**Massari Theater Renovation
TSJC-21-001**

ADDENDUM No. TWO (2)

The original Plans and Specifications, dated April 14, 2021 for the project noted above, are amended as indicated and described in this Addendum.

ELR WIRING DIAGRAM - APPLIES TO BE, LE & FE FIXTURES
NO SCALE

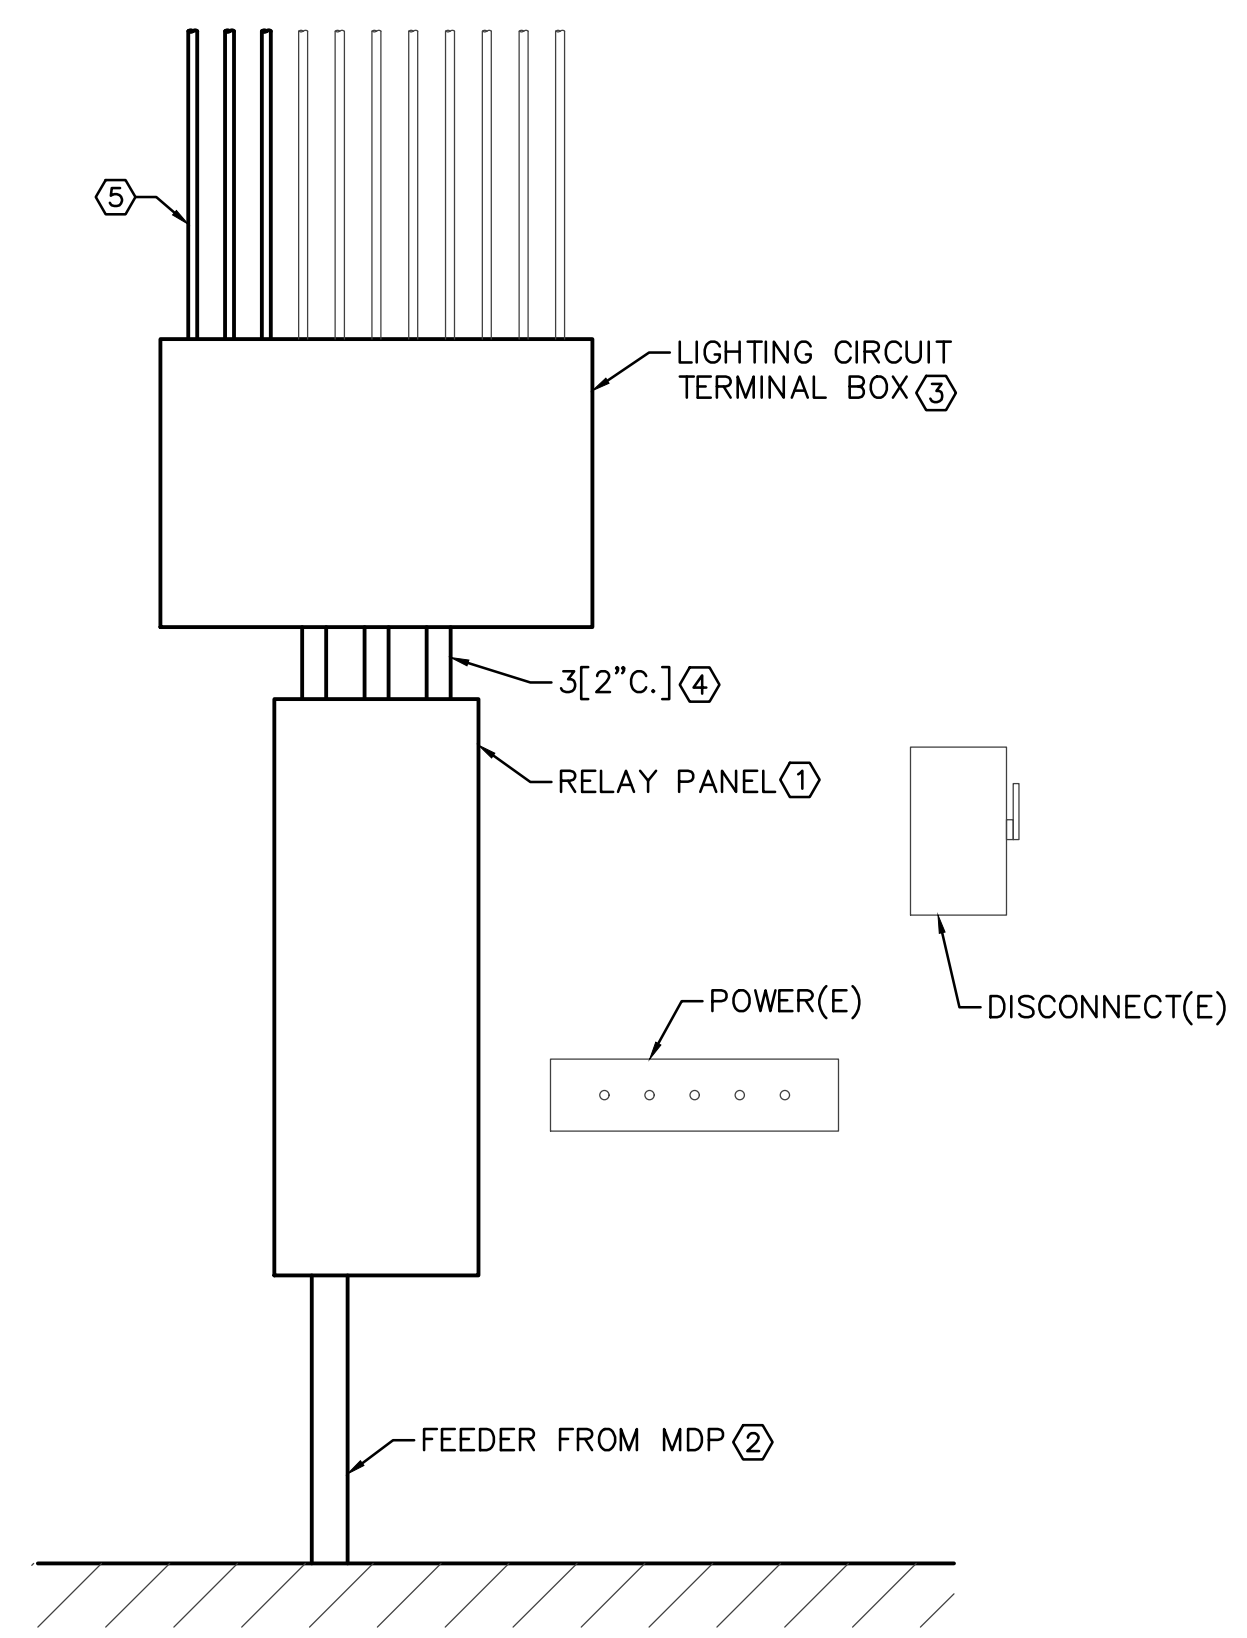
3. Re: Emergency Lighting and Control:
- Sheet E-501 - Details "ELR Wiring Diagram" indicates EM lighting to be controlled by an ELR - this device is undefined (is this supposed to be an ALCR - see 2020 NEC Article 700.26) and it appears the Emergency fixture is also controlled with a normal lighting zone
E-501 is updated to refer to theatrical. One run of power is fed to the EM fixtures and the source for that feed is switched on/off by a Foundry Relay. When emergency battery is triggered, source of power switches via SC1008. See TS sheets for details.

4. - Detail "House Emergency Lighting" implies Emergency Light Fixtures are DMX controlled and sensing normal power but connected to EM power - appears the fixtures would need to be UL924 listed? (see 2020 NEC Article 700.24)
EM fixtures intent is not DMX controlled - relay that controls their normal power is DMX controlled.- Drawing TS-108 shows using an ETC SC1008 BCELTS UL1008 listed transfer device to xfer the EM lighting from normal power control (Relay Panel) to EM power upon loss of normal power. Seems to be missing normal power sensing. TS-108 & 113 both show normal power for SC1008 fed from 20amp breaker in Panel B through a DMX-controlled Foundry Relay, and sense power fed directly via separate 20amp breaker in Panel B. E501 is updated to remove detail

1. E501
Emergency lighting detail removed
2. TS-107
Fixture Wattages
3. TS-108
Fixture selection
4. TS-113
Narrative

SHEET:
TS-107

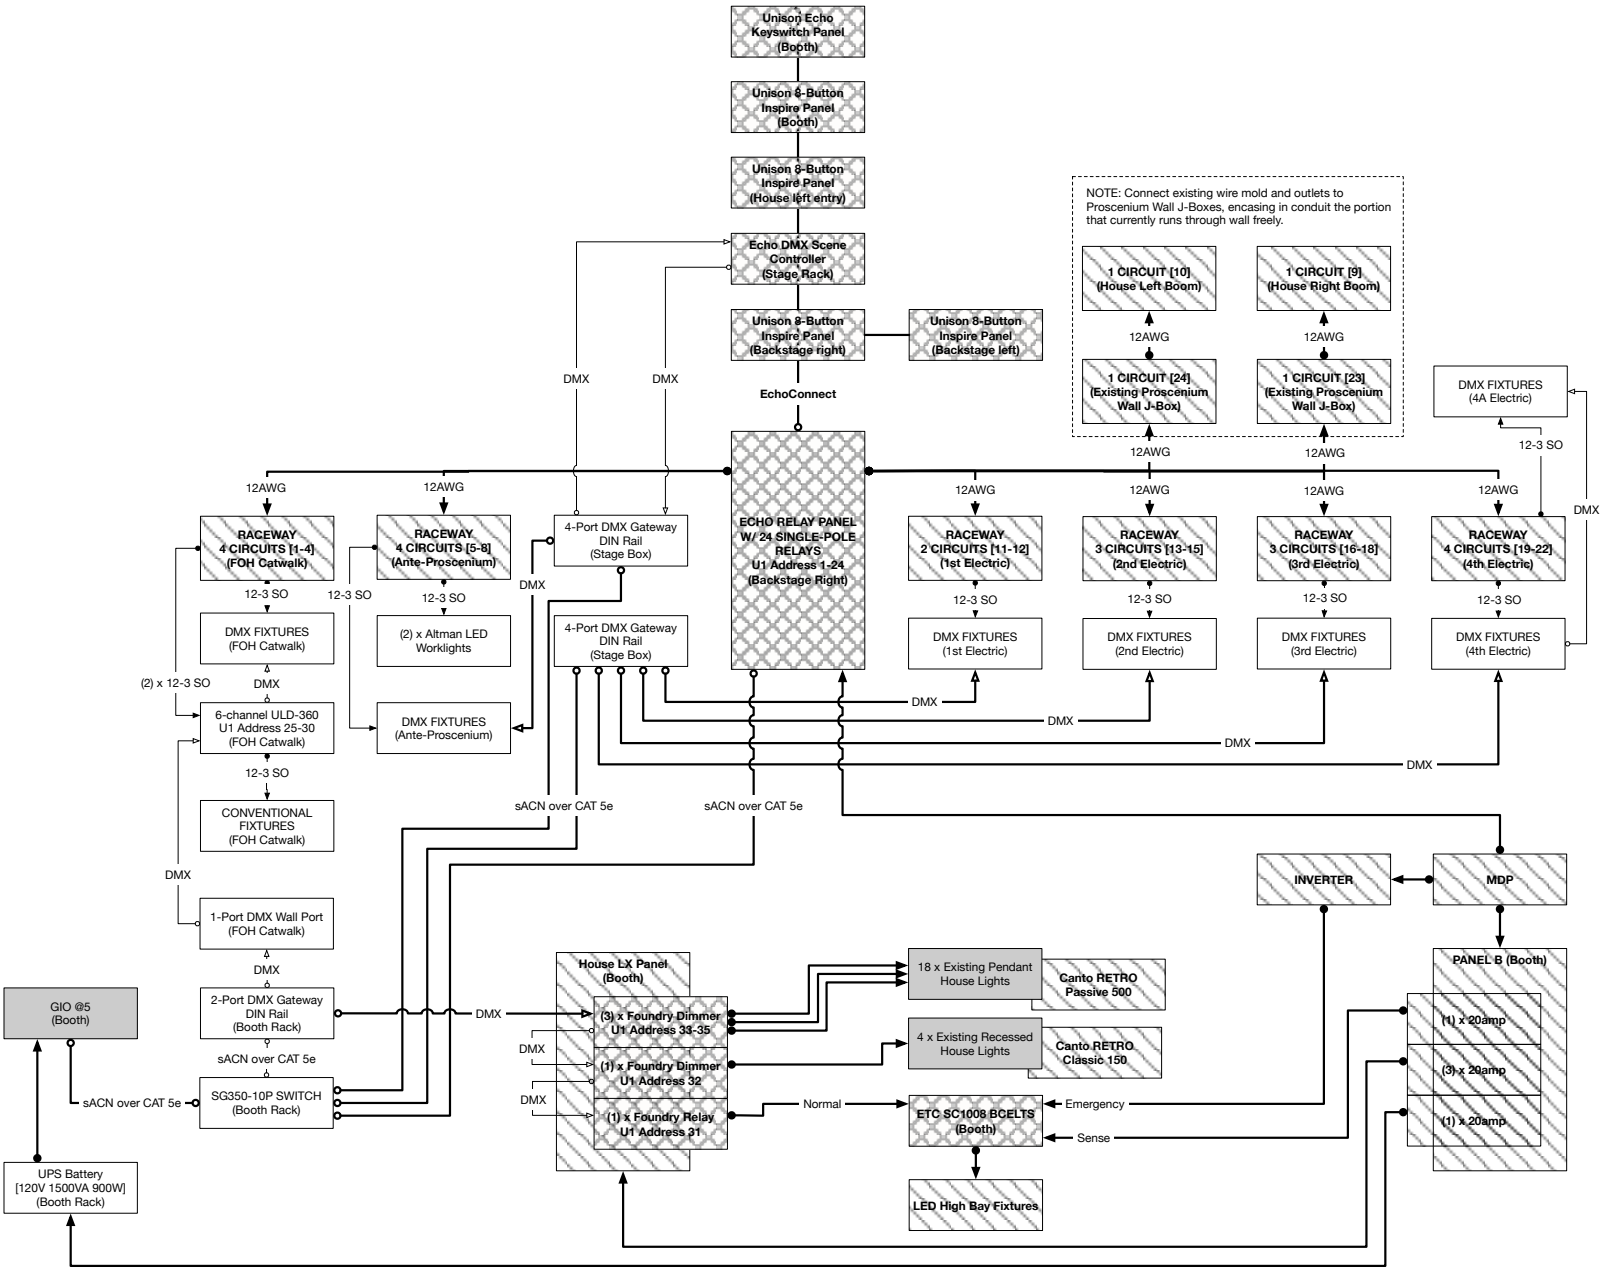
2. Drawing TS-107 Symbol Key shows Pendant LED Retro at 100w. The Passive 500 is 50w and the Passive 700 is 72w. Please clarify.
Drawings updated to reflect accurate wattages.

- NOTES:
- 1) All House Lights are on ETC Foundry Dimmers or Relays.
 - 2) For specifications on retrofit units, see project manual.
 - 3) Δ2: CORRECTED FIXTURE WATTAGE BELOW

MASSARI HOUSE LIGHTING PANEL

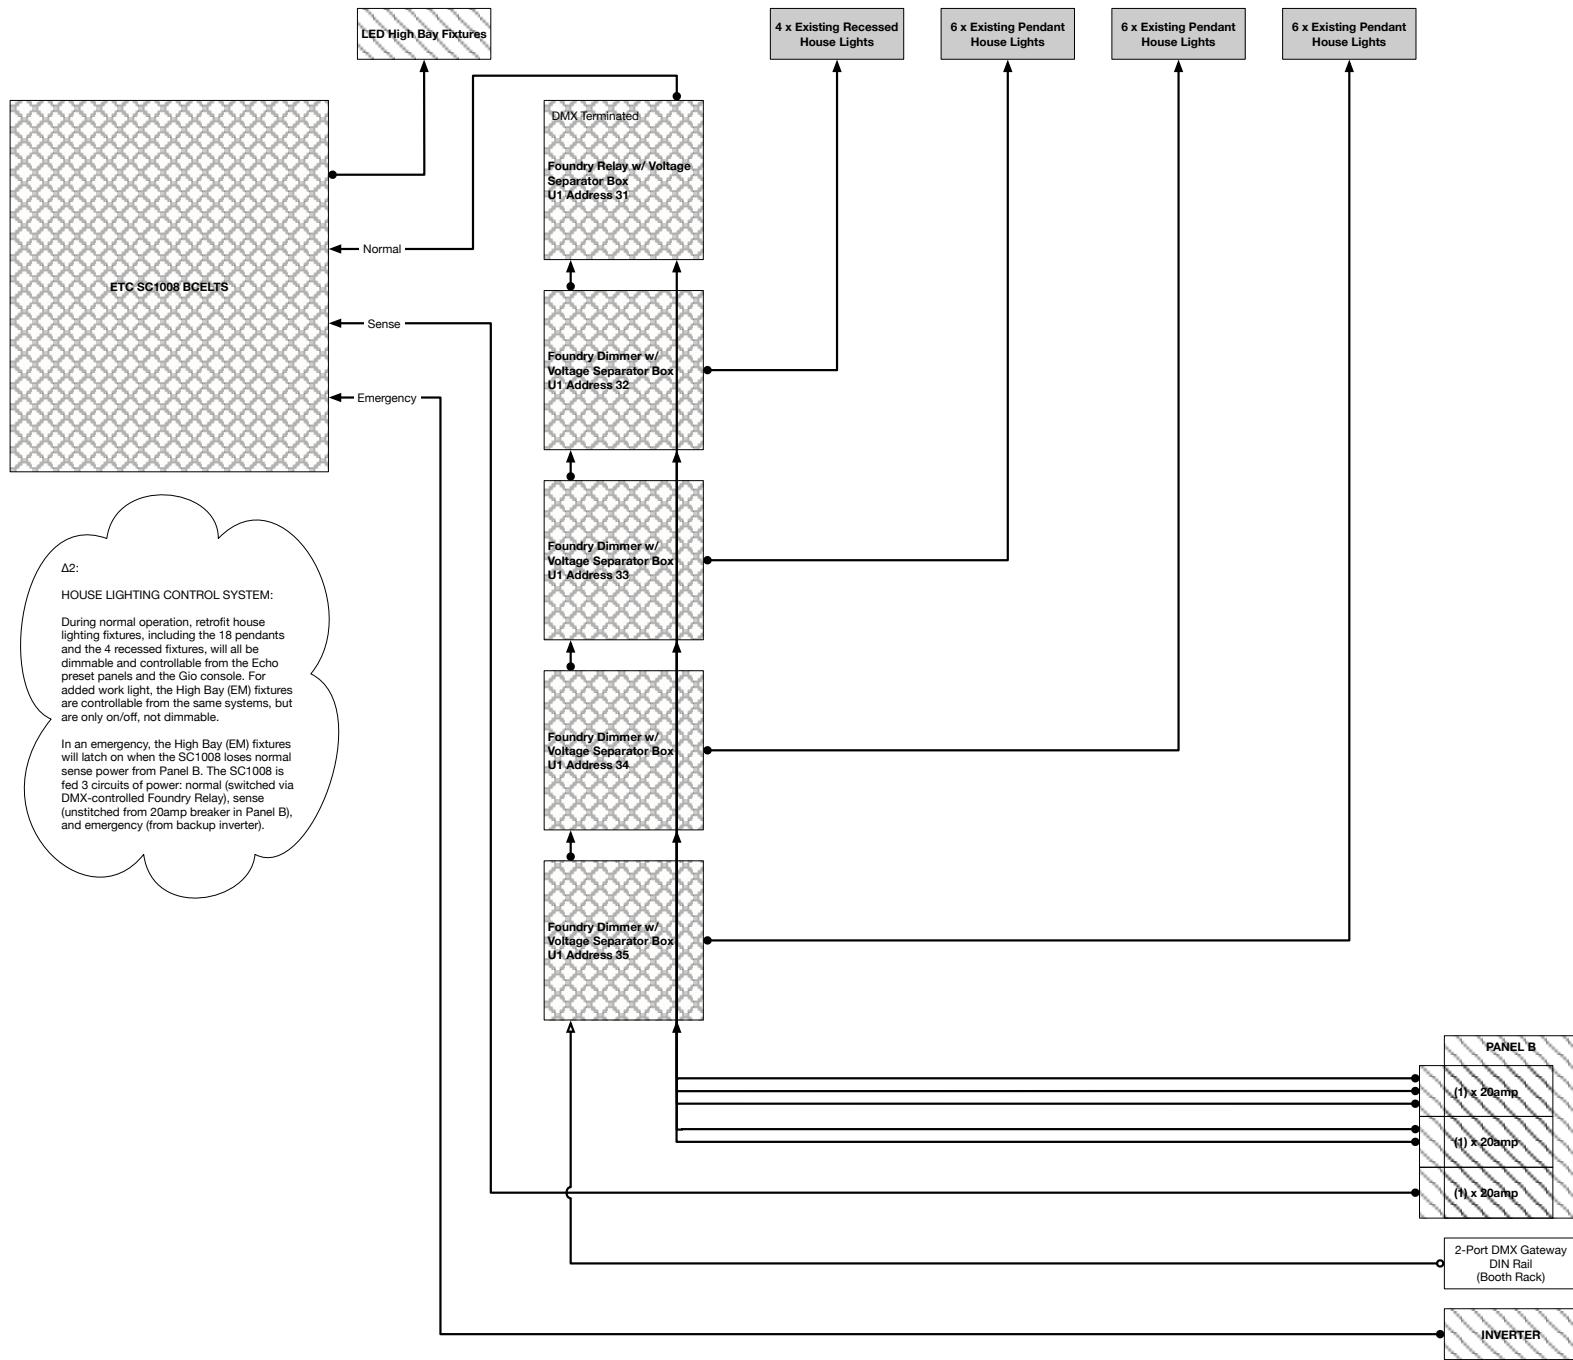
5. Drawing TS-113 shows using an ETC SC1008 BCELTS UL1008 listed transfer device to xfer the EM lighting from normal power control (Relay Panel) to EM power upon loss of normal power.

9. Please advise intent and can the associated drawings (E & TL) be updated to eliminate confusion and include an operational narrative for identification of operational intent?
Narrative added on TS-113.

Δ2:
HOUSE LIGHTING CONTROL SYSTEM:

During normal operation, retrofit house lighting fixtures, including the 18 pendants and the 4 recessed fixtures, will all be dimmable and controllable from the Echo preset panels and the Gio console. For added work light, the High Bay (EM) fixtures are controllable from the same systems, but are only on/off, not dimmable.

In an emergency, the High Bay (EM) fixtures will latch on when the SC1008 loses normal sense power from Panel B. The SC1008 is fed 3 circuits of power: normal (switched via DMX-controlled Foundry Relay), sense (unswitched from 20amp breaker in Panel B), and emergency (from backup inverter).
